IREDELL COUNTY HEALTH DEPARTMENT

PERMIT # 236100

SEPTIC IMPROVEMENT PERMIT / AUTHORIZATION TO CONSTRUCT / OPERATION PERMIT / EXISTING SYSTEM

SITE ADDRESS: 174 Rain Shadow Dr. Mooresville, NC 28115 PHONE: 704-361-9395 ALT. PHONE

INITIAL SITE SKETCH

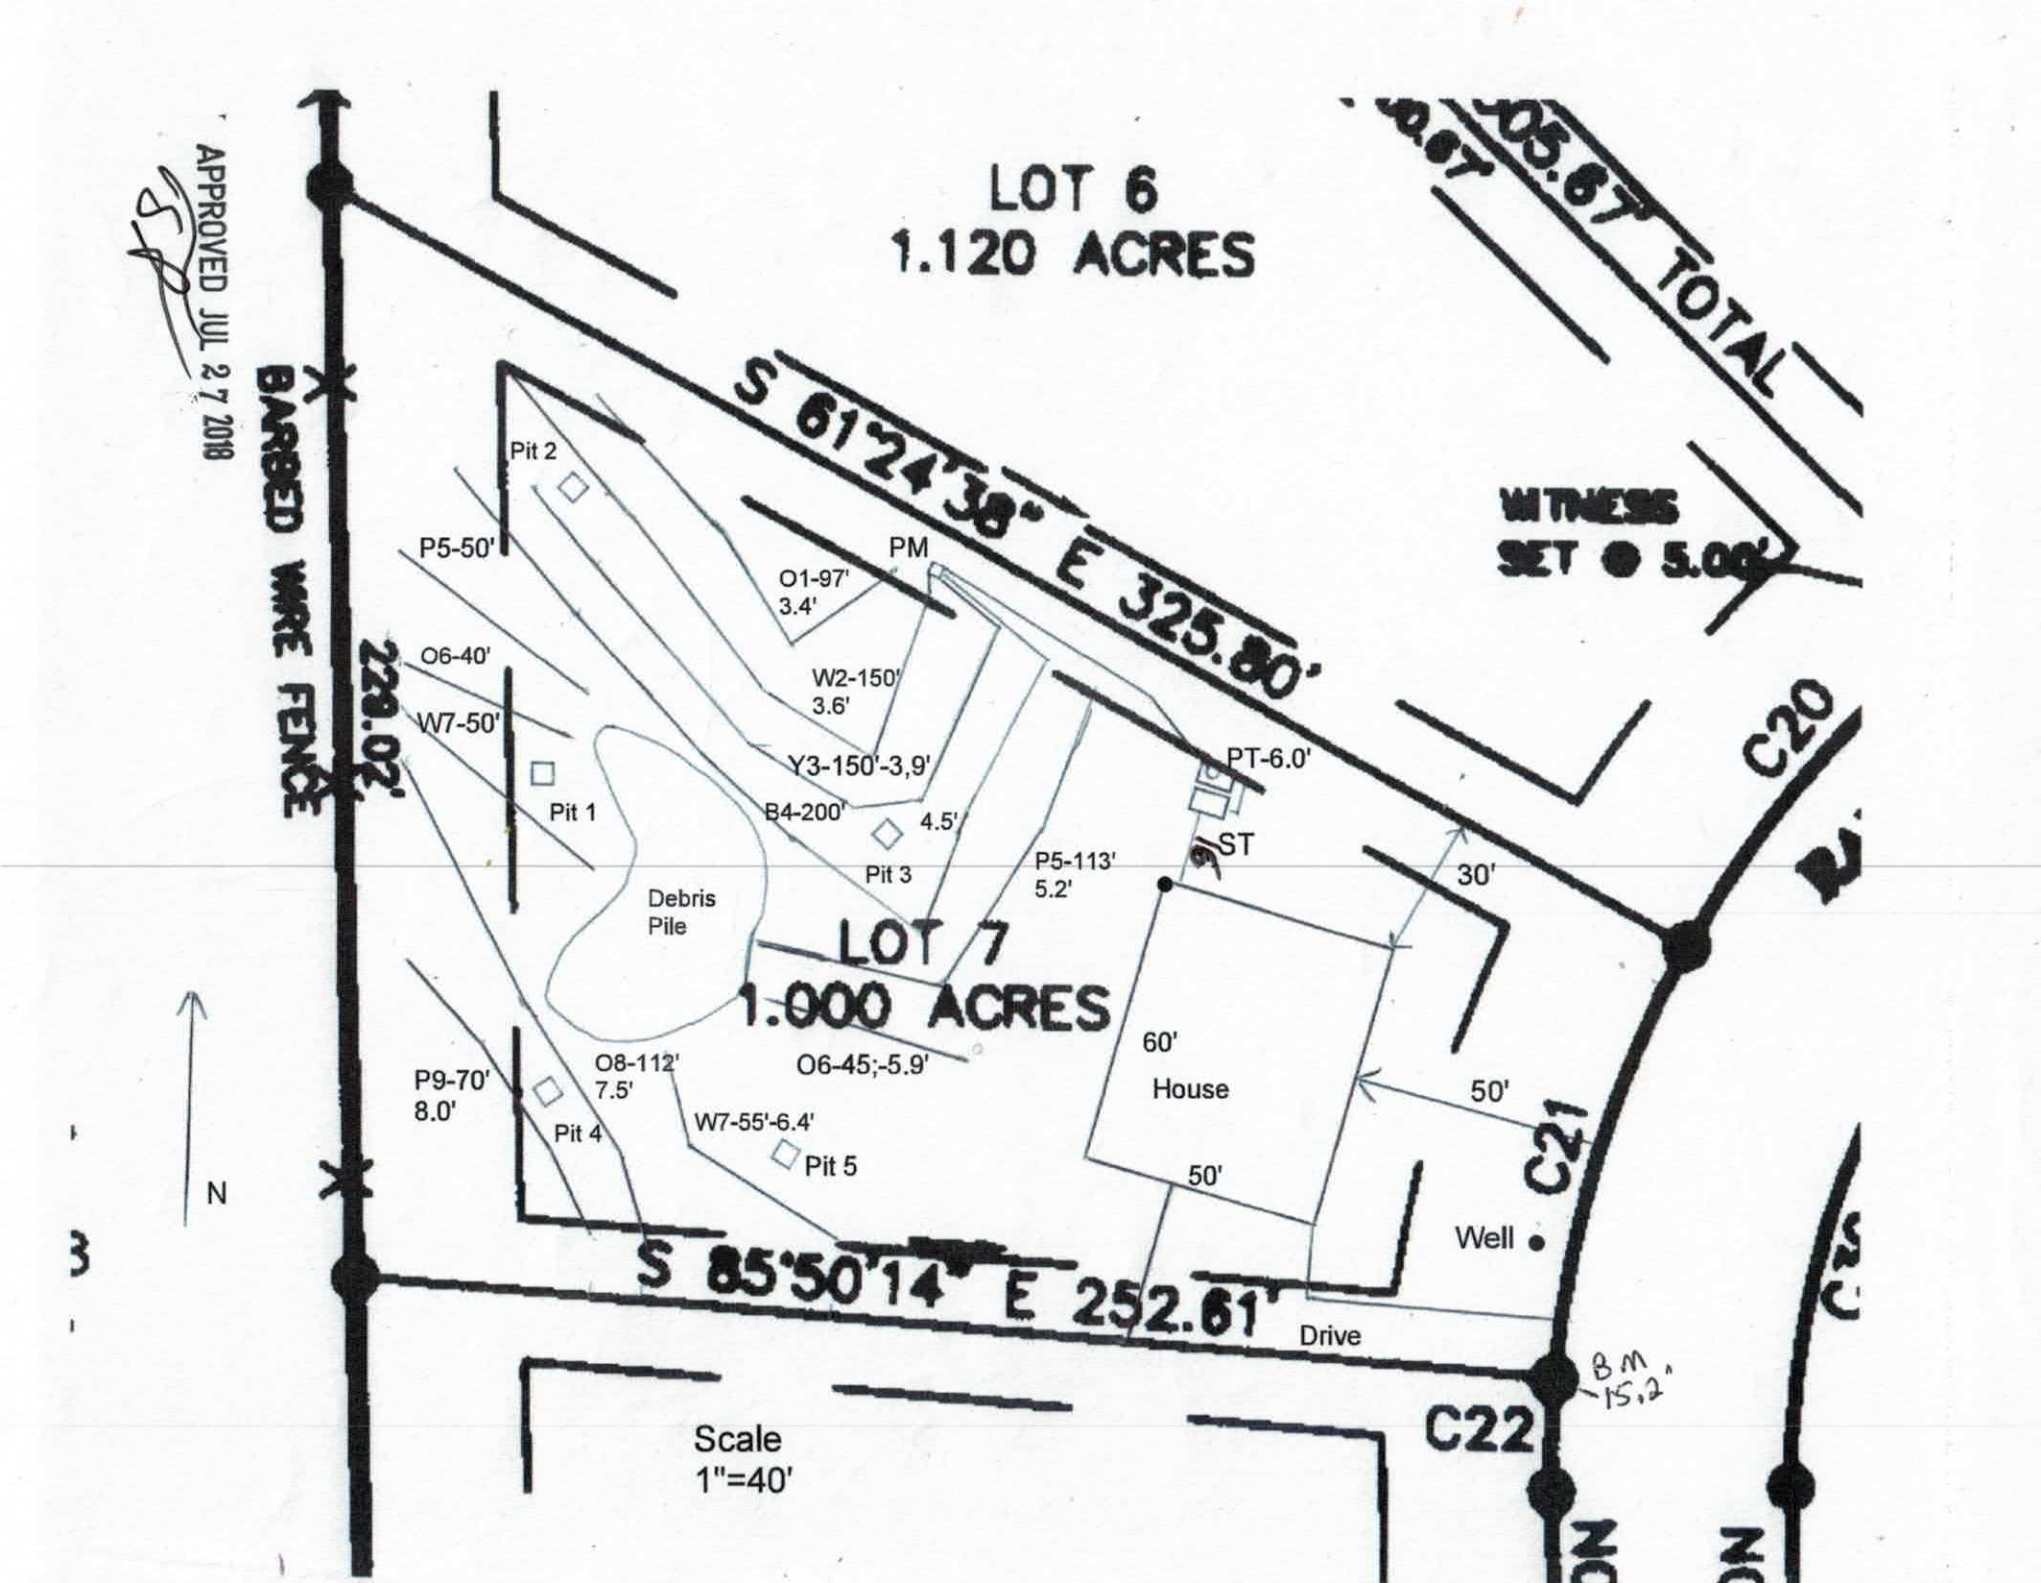
Comments / Conditions: Recommend pumping tank every 3-5 years. If spoil/debris pile is removed from drainfield area, DO NOT spread across permitted primary or repair drainfield areas. Recommend that it be moved off-site. 8/3/18: House floorplans are 2' beyond the 60' House box dimension. That 2 additional feet MUST extend towards Lot #8 to ensure tanks maintain enough room/setbacks.

FIRST FLOOR PLAN 'A'
1/8" = 1'-0" @ 11x17

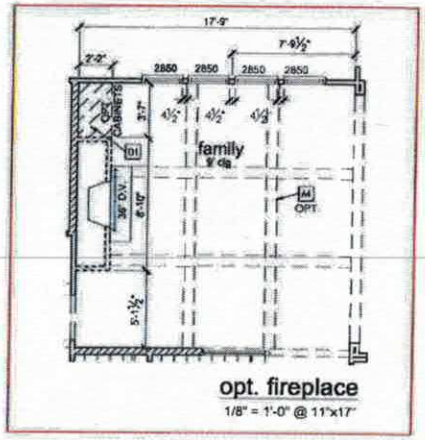
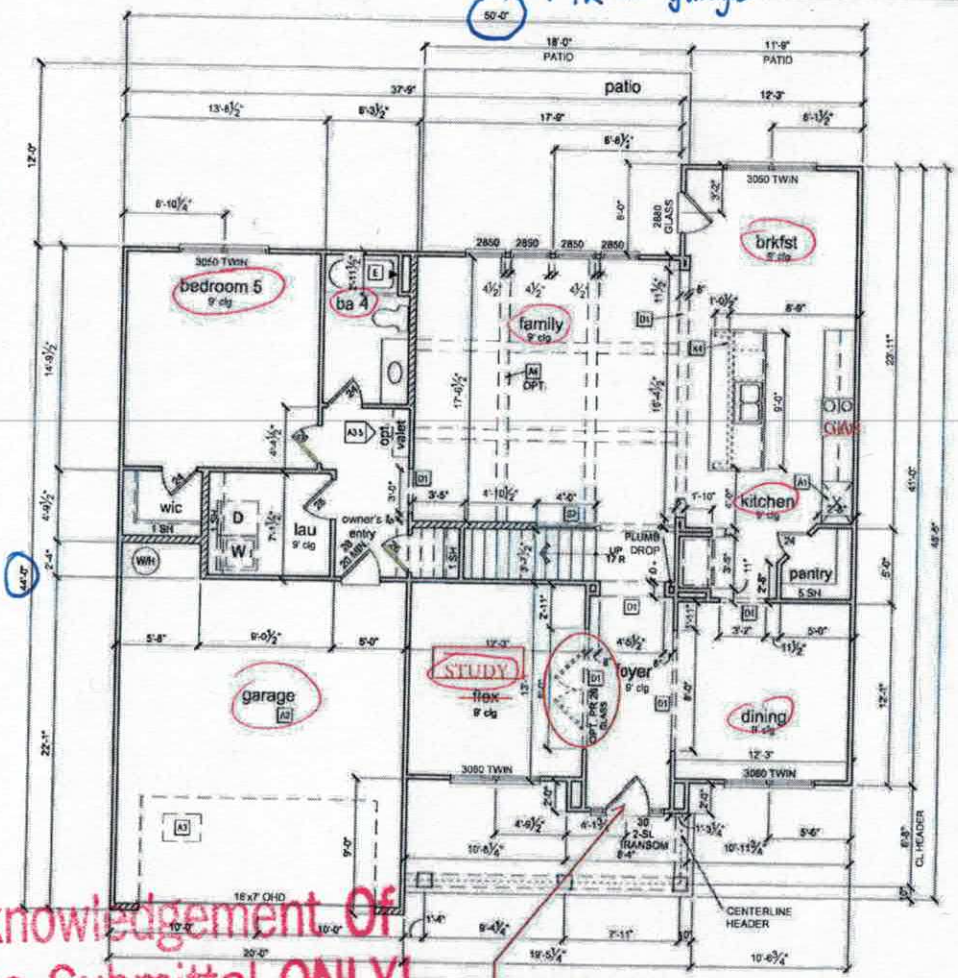
+ 12' for garage
